Container for low-enriched uranium

**INDEPENDENT REVIEW OF DOCUMENT
0908-LE01-3BEIN-024-B: LEUPA -
CRITICALITY ANALYSIS**

Document NO.: 0908-LE02-3BEIN-007 Revision: A			
		Document Title: INDEPENDENT REVIEW OF DOCUMENT 0908-LE01-3BEIN-024-B: LEUPA - CRITICALITY ANALYSIS			
REVISION SHEET		Ref. NO.:			
		Write name, date and sign			
Revision Letter	Description of the Revision	Prepared by	Revised by	Approved by	
A	Original	FA	NG	JCO

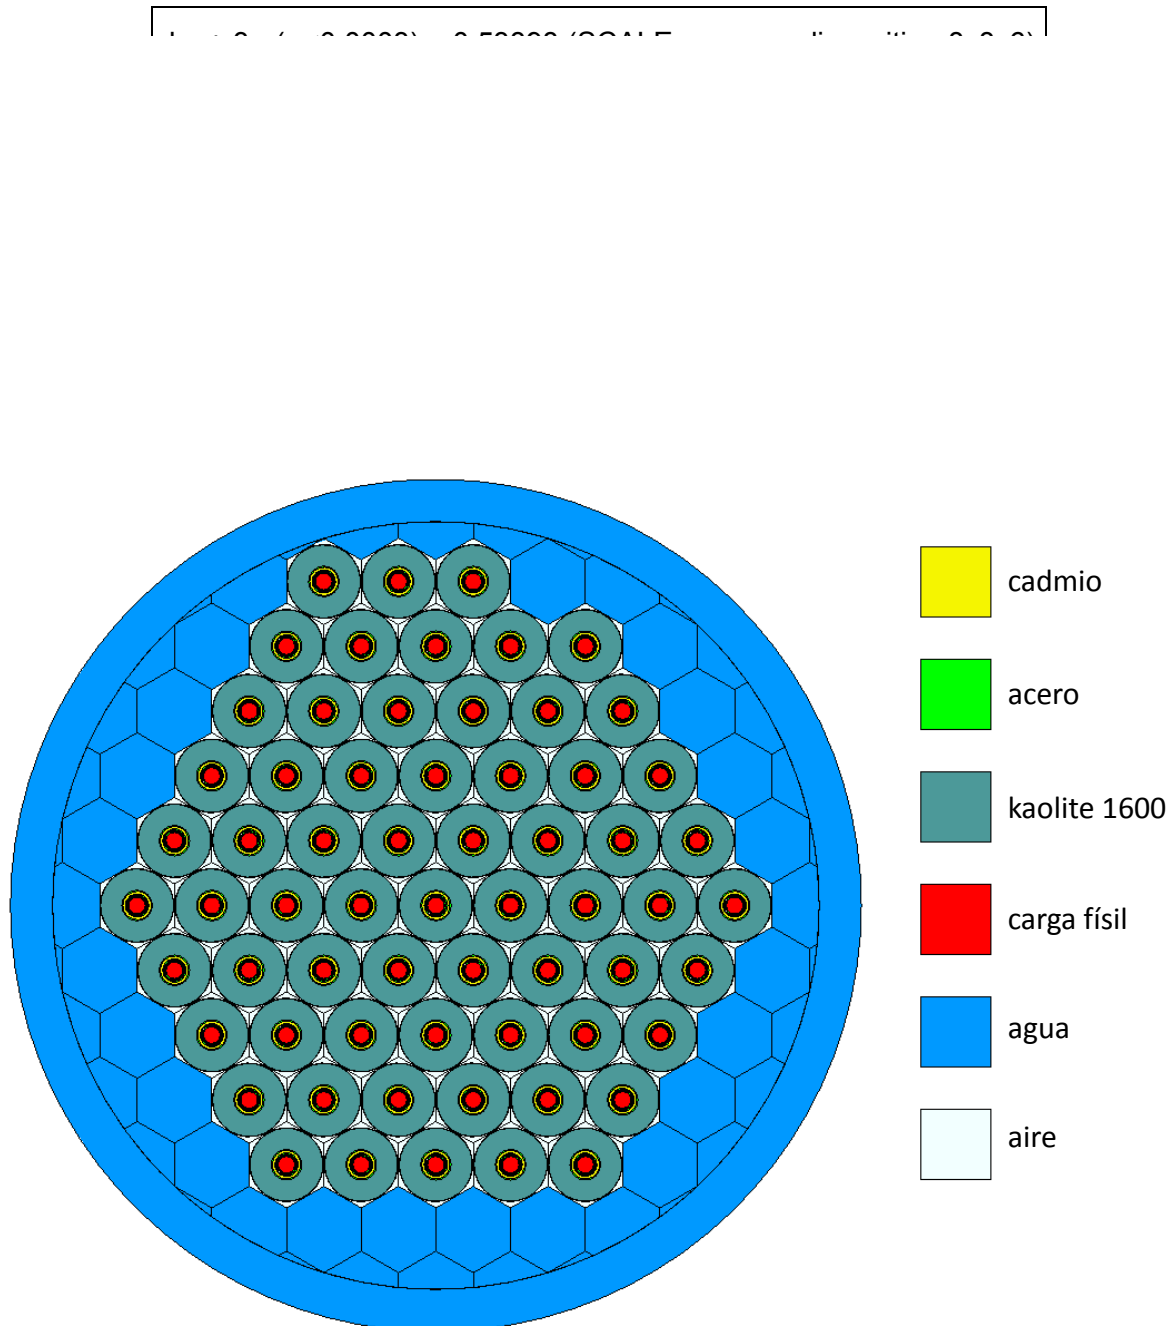
7. Given this result, and because the cadmium chamber does not fully cover the container - the cadmium chamber is interrupted in the area of the flange of the container cap, **Figure 1** and **Figure 2** -, it is also relevant to assess the effect of a potential inversion of the package (i.e., if, for any reason, the package rested on the cover instead of the base). Thus, the fissile load in one of the internal containers would be surrounded by less cadmium than the remaining containers, and it is therefore expected that the reactivity of the system in this situation will be higher. The result of this simulation is as follows:

8. The effect of inverting the package is therefore reduced. The modeled case is useful to prove the subcriticality of the packages disposition, regardless of the vertical position of the packages.
9. To evaluate the effect of assuming a different geometric arrangement of packages, a case in which packages are distributed in an hexagonal arrangement was simulated (Figure 4), keeping the same 6 axial levels assumed on the square disposition. The result is as follows:

Figure 5: Variation of the effective multiplication factor based on the mass of water retained in the Kaolite 1600

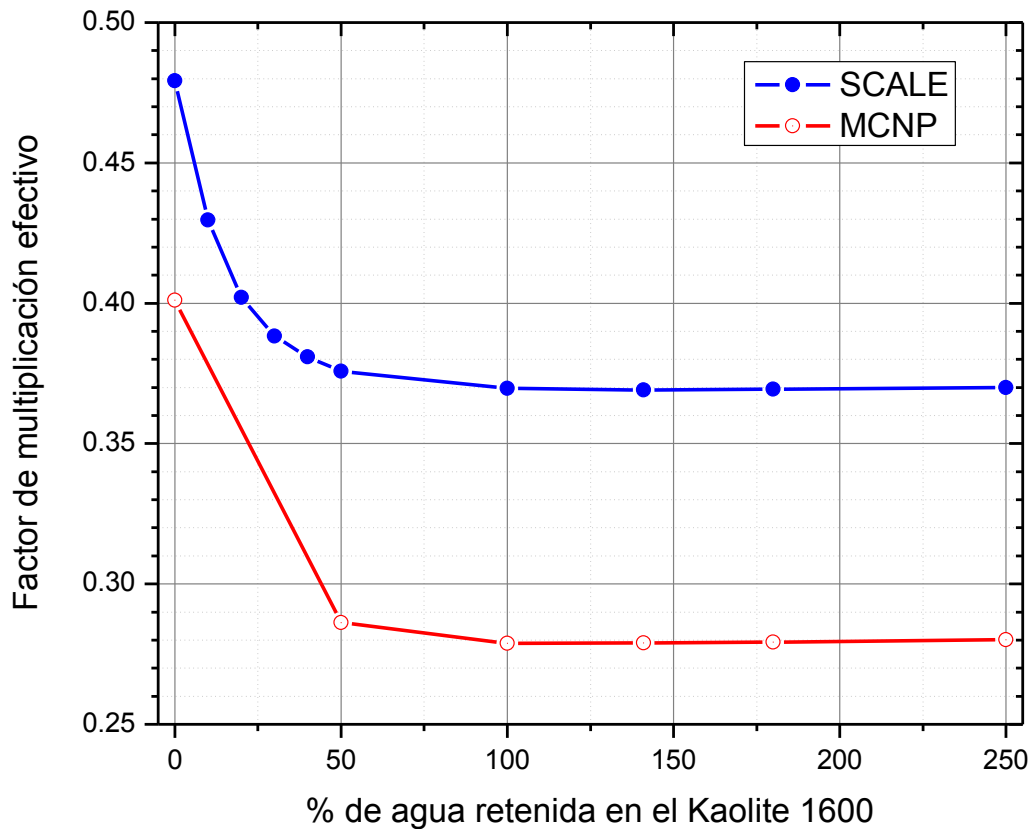
4. Figure 5 contains a graph on the values of ($k_{ef} + 3\sigma$) obtained with MCNP and SCALE, based on the percentage of water retained by the insulation.
5. The SCALE calculation confirms that the most unfavorable situation from the criticality standpoint is the case of dry heat insulation, as stated in [2].

3. The thermal insulation was considered without water content. As mentioned in section 7.4.2.1, paragraph 5, this condition of water content in the insulation is the most unfavorable from the criticality standpoint.

Figure 6: Variation of the effective multiplication factor based on the density of water entering the empty spaces inside and outside the package

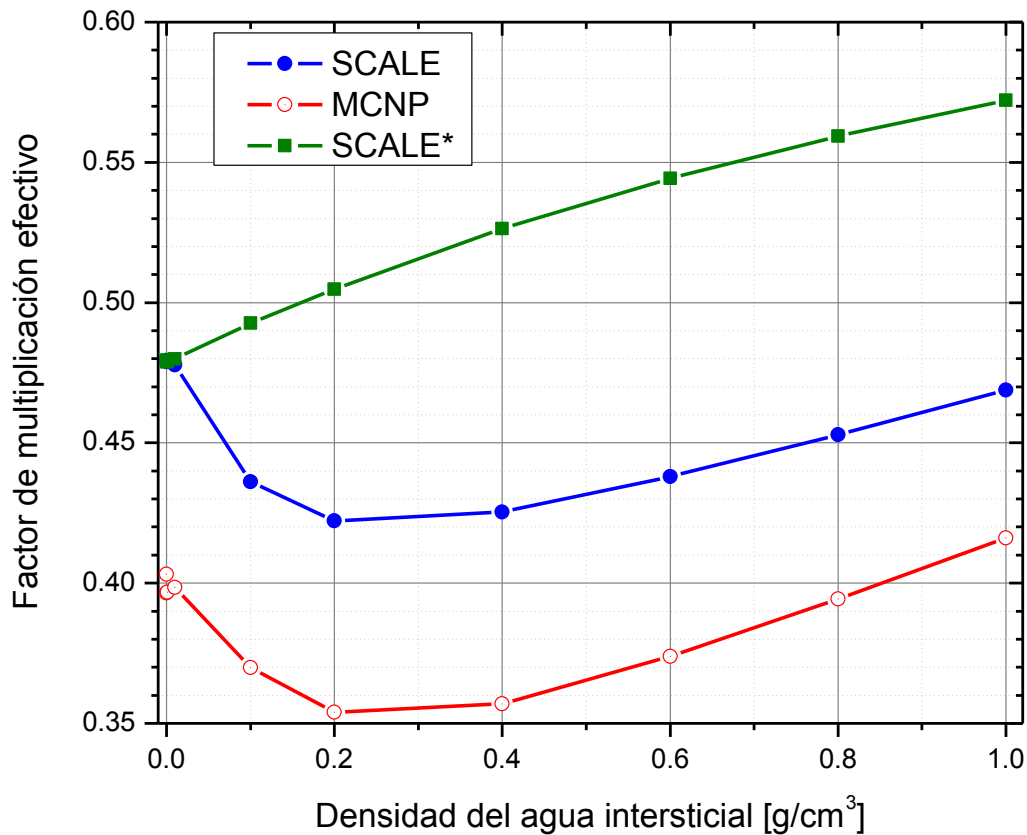
5. Figure 6 shows the values calculated with MCNP (red curve, empty circles) and SCALE (blue curve, solid circles). The existence of a minimum based on the density of the water

entering the package suggests the presence of phenomena competing among them in relation to the reactivity of the system. In order to identify and separate these phenomena, another series of calculations was prepared, where the inflow of water to the package was simulated, but only to empty spaces located within the confinement system. In other words, we simulate a scenario where there is water inflow only through empty spaces located on the inside of the cadmium cover. The results obtained are shown in the last 3 columns of Table 3, under the heading "SCALE* (H₂O confinement only)".

- The curve indicated as "SCALE*" (green curve) in Figure 6 shows that the more reactive case is that where the water inflow only to the existing empty spaces inside the cadmium cover is simulated. This water provides moderation to the sub-moderate system and therefore the multiplication factor increases with the inflow of water.
- On the contrary, when water is also added outside the cadmium cover, the additional moderation obtained does not translate into an increase of the effective multiplication factor of the system, since the thermalized neutrons in the area outside the cadmium cover are absorbed in the cadmium before re-entering the containers with fissile material.

Figure 7: Variation of the effective multiplication factor based on the mass of water entering each internal container

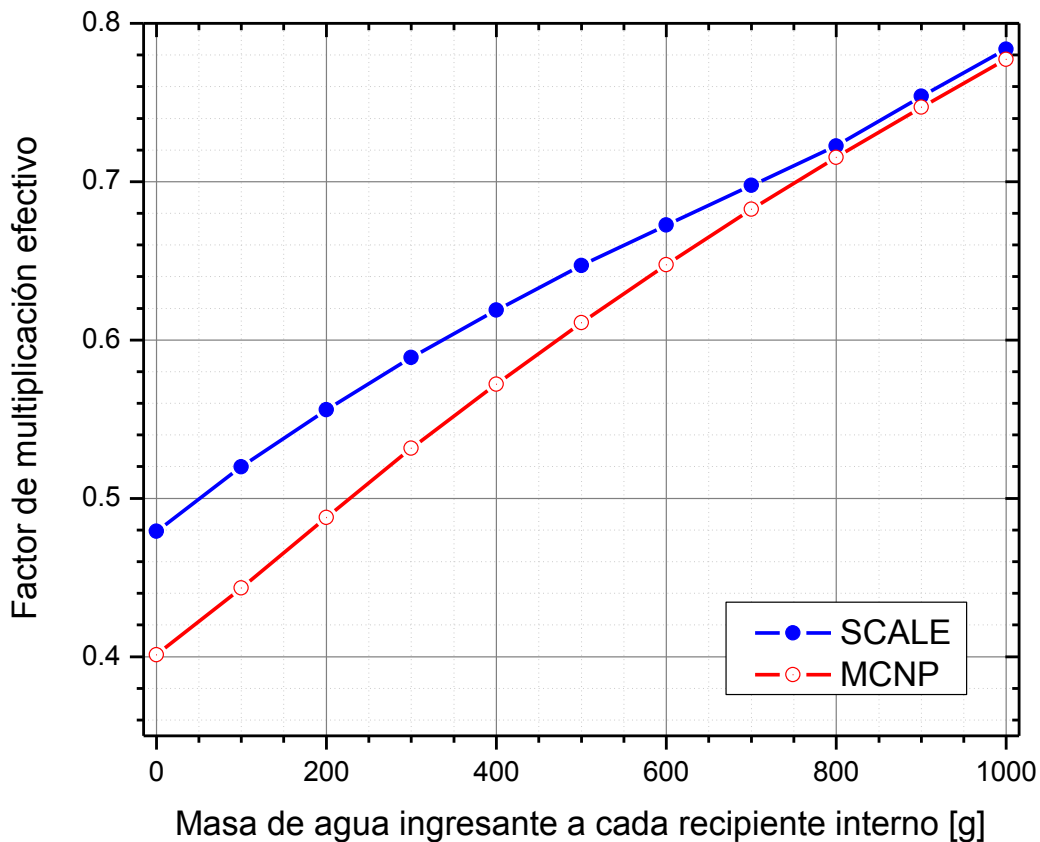
6. **Figure 7** contains the calculated values.
7. We can see that the multiplication factor increases monotonously with the water mass entering the inside container. Be it reminded that, given the measurements of the internal containers and the nominal mass of uranium metal per container, it is not possible to add more than 900 g of water per internal container.
8. In all cases, the value calculated with SCALE is higher than the value calculated with MCNP. The difference between both calculations is reduced to a minimum as the mixture of water+uranium metal modeled in SCALE fills the free volume of each interior container, since the differences in the fissile volume modeled with both codes is reduced when water is added to the container. This behavior confirms what is stated in section 7.4.1, paragraphs 3 to 6.

Figure 8: Variation of the effective multiplication factor depending on the density of water entering the gaps in the packages arrangement, when the insulation is dry

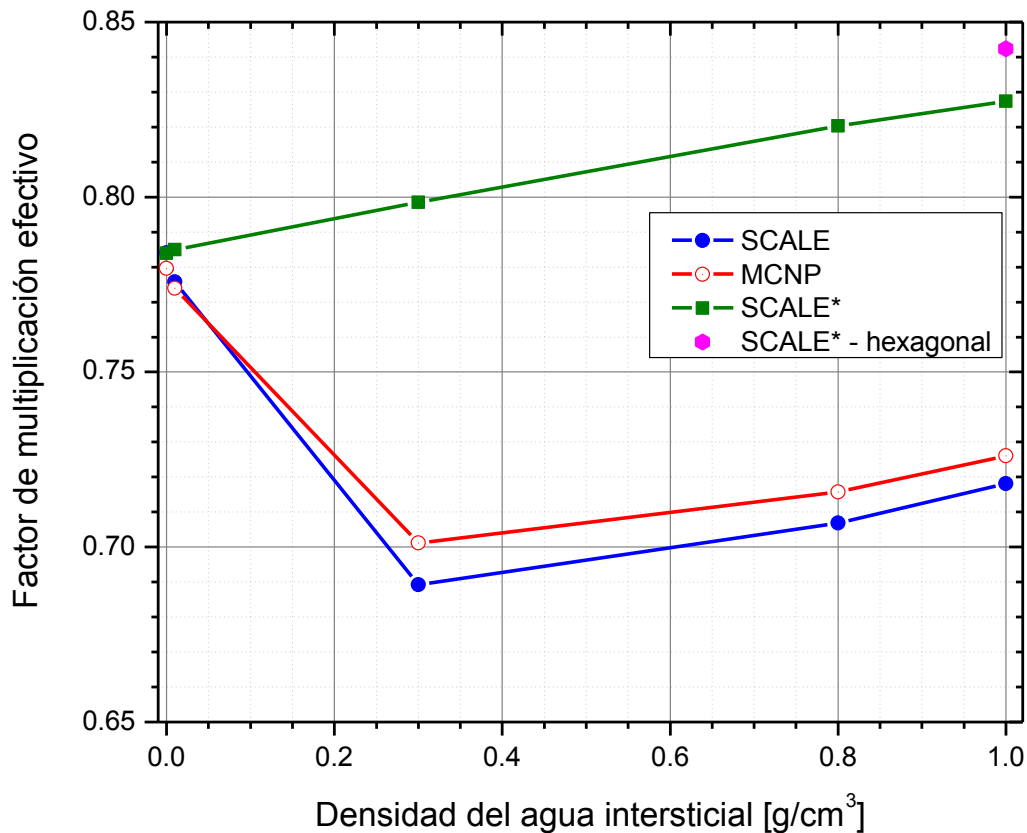
11. It is precisely in this group of cases calculated with SCALE where the more reactive case is identified: internal containers flooded with water (1000 g water per container), dry thermal insulation, and maximum density of water in empty spaces located inside the confinement.

12. Cases resulting in the maximum k_{eff} obtained with MCNP and SCALE are highlighted in **Table 5**.
13. **Figure 8** contains a graph of the results obtained with MCNP and SCALE, for cases where the insulation is dry, for different densities of water entering the gaps (homogeneous inflow of water in all the gaps of packages, and inflow of water only to the gaps located to the interior of the confinement, indicated with the label "SCALE *" in **Figure 8**).

14. In all those cases, a square arrangement of packages was simulated in the system. Figure 8 also shows a calculation point that corresponds to the simulation of an hexagonal arrangement of packages in the system ($k_{\text{eff}}+3\sigma = 0.84234$).

Figure 9: Multiplication factor depending on the density of the interstitial water, for different cases in which cadmium did not infiltrate into the cadmium chamber

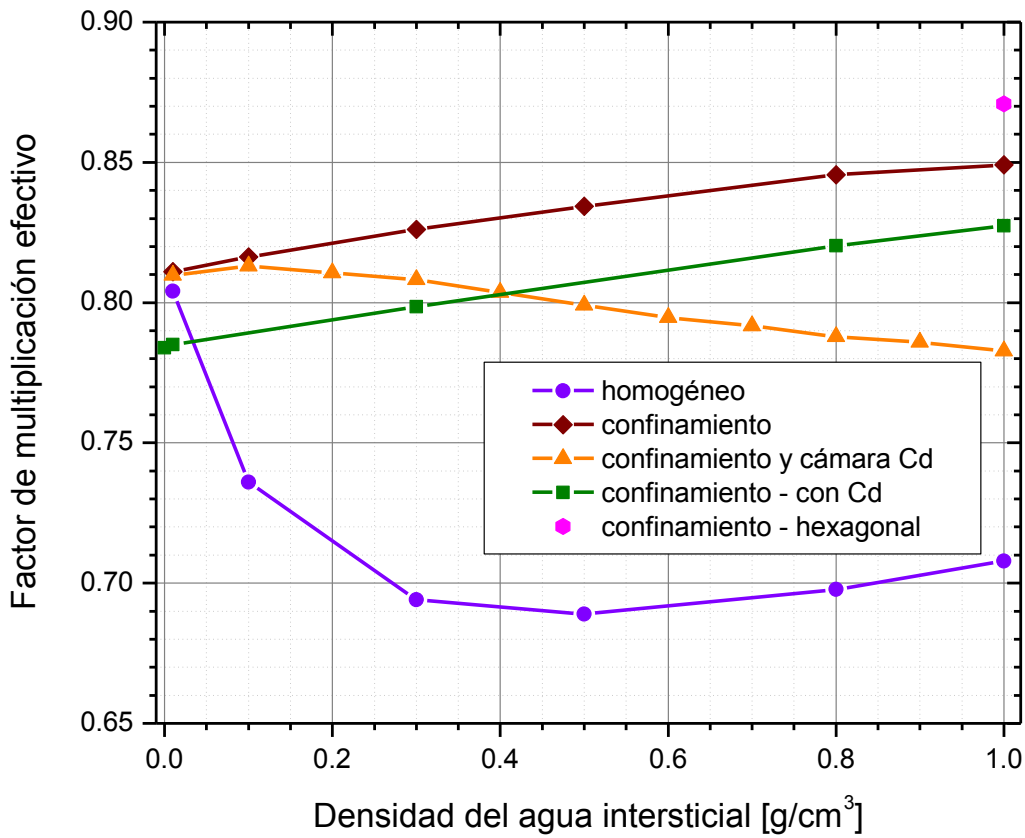
9. The curve displayed in Figure 8 is repeated in Figure 9 when water enters only the interior of the confinement (curve labeled as "confinement - with Cd"), for the sole purpose of making the effect of removing the cadmium from the cadmium cover visible.

10. In all those cases, a square arrangement of packages was simulated in the system. Figure 9 also shows a calculation point that corresponds to the simulation of an hexagonal arrangement of packages in the system ($k_{ef}+3\sigma = 0.87083$).

11. It can be seen that, again, the worst case is the one in which internal containers are flooded with water (1000 g of water), the insulation is dry, water enters only into the gaps within the confinement, and the density of water in these empty spaces is equal to 1 g/cm^3 . This case, which yielded the highest effective multiplication factor of all those evaluated so far, shows that even under the hypothesis of this accidental case, the subcriticality of the packages system is assured with one sufficient margin.
